Park Street Bike Link

Safe System Assessment

Report for SMEC

DATE: 21/09/2021

Figure 6 Parked vehicles block kerbside cyclist

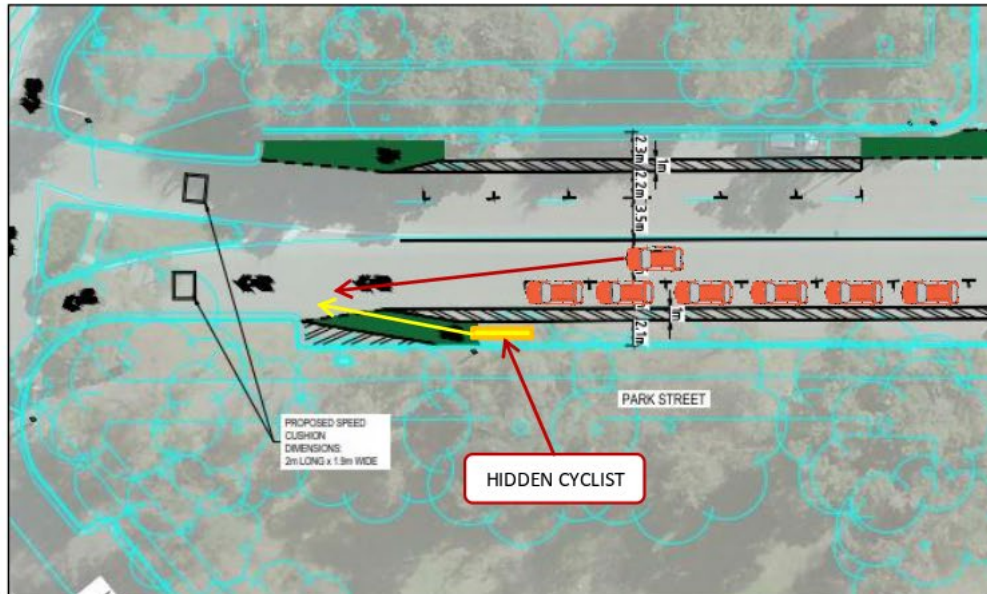
- The design proposes a 1.0m wide buffer between the parking lane and bicycle facility. There is still a risk of a dooring type collision (passenger side door opening)
- Sharrow markings are provided throughout the circulating carriageway and on some approaches of the roundabout indicating to motorists that cyclists share the traffic lane
- Westbound traffic approaching the Heather Street roundabout may not expect to see cyclists come from the kerb and claim the traffic lane. Parked cars would inhibit sight lines. This risk has been shown in **Figure 6**

3. Consider installing the speed cushions on all approach legs of the Heather Street roundabout.
4. A door can swing approximately 1.2m from a vehicle. Wherever parking is proposed adjacent the bicycle lane, consider increasing the buffer to cater for a full door opening. This is particularly relevant to the 0.3m buffer proposed in some locations. If the buffer cannot be increased, consider removing parking to remove this risk.

Figure 7 Passenger side dooring risk

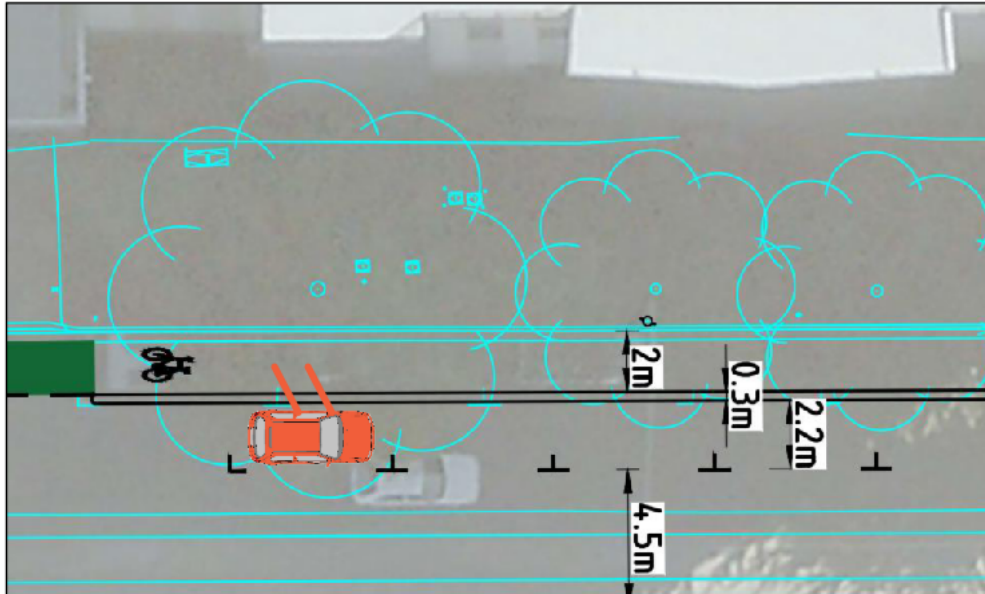
- The design proposes a 0.3m wide buffer between the parking lane and bicycle facility. There is a risk of a dooring type collision (passenger side door opening). This risk has been shown in **Figure 7**
